## HISTORIC AND DESIGN REVIEW COMMISSION

**HDRC CASE NO:** 2024-341  
**ADDRESS:** 634 CEDAR ST  
**LEGAL DESCRIPTION:** NCB 2912 BLK 1 LOT S 10 FT OF 8 & N 40 FT OF 9  
**ZONING:** RM-4, H  
**CITY COUNCIL DIST.:** 1  
**DISTRICT:** King William Historic District  
**APPLICANT:** Victoria Gough/Lush GreenScape Design  
**OWNER:** Alejandro Garcia/GARCIA ALEJANDRO A  
**TYPE OF WORK:** Demolition of rear accessory structure, carport installation, fence installation, site modifications  
**APPLICATION RECEIVED:** October 24, 2024  
**60-DAY REVIEW:** December 23, 2024  
**CASE MANAGER:** Bryan Morales  
**REQUEST:**

The applicant is requesting a Certificate of Appropriateness for approval to:

6 STEEL RISER STEPS

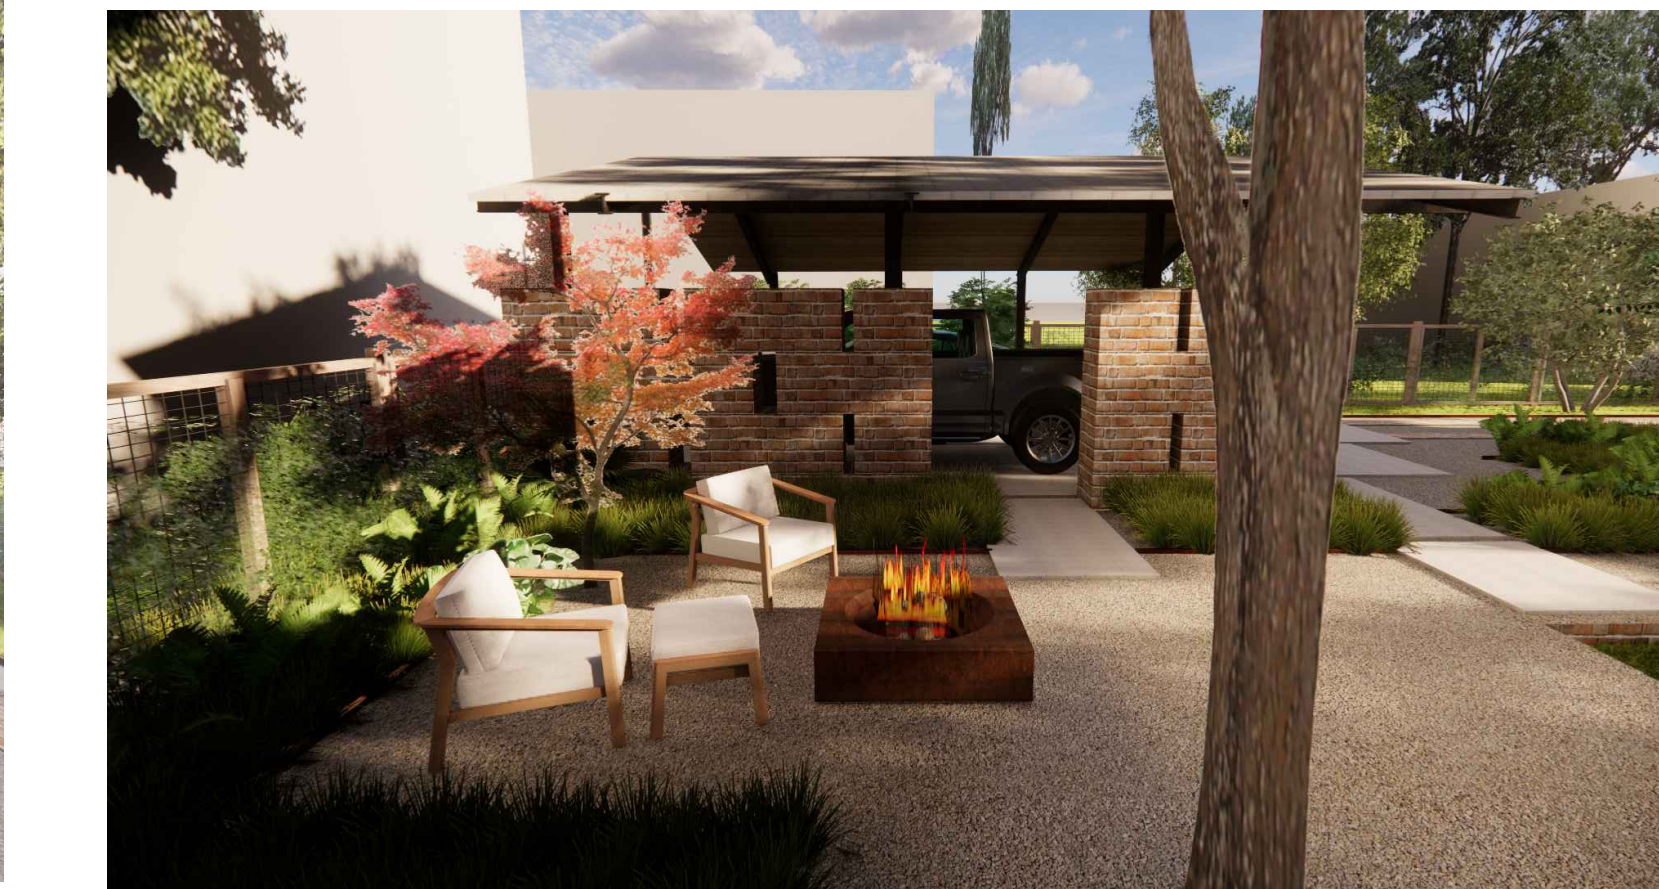
Board (CTAB) Jason Vasquez in attendance. Discussion focused on the proposed carport's architectural features, the incorporation of brick planters at the front, and the installation of steel risers on the existing porch steps. Overall, commissioners recommended the applicant incorporate some character-defining features found on the existing detached garage on the proposed carport and lower the height and prominence of the brick planters.

- j. **FRONT PORCH STEP MODIFICATION** – The applicant has proposed to replace the existing concrete front porch steps with new concrete front porch steps featuring a wider step and a lower run with steel risers. Guideline 7.B.iii. states that porches, balconies, porte-cocheres, and related elements, such as ceilings, floors, and columns, should be replaced in kind when such features are deteriorated beyond repair. When in-kind replacement is not feasible, the design should be compatible in scale, massing, and detail while materials should match in color, texture, dimensions, and finish. Additionally, Guideline 7.B.iv. for Exterior Maintenance and Alterations states that replacement elements, such as stairs, should be designed to be simple so as to not distract from the historic character of the building. Do not add new elements and details that create a false historic appearance. While the existing front porch steps are likely not original to the structure, staff finds the proposed modification to be inconsistent with the Guidelines.

Item 3, staff does not recommend approval of the front porch step modification based on finding j.
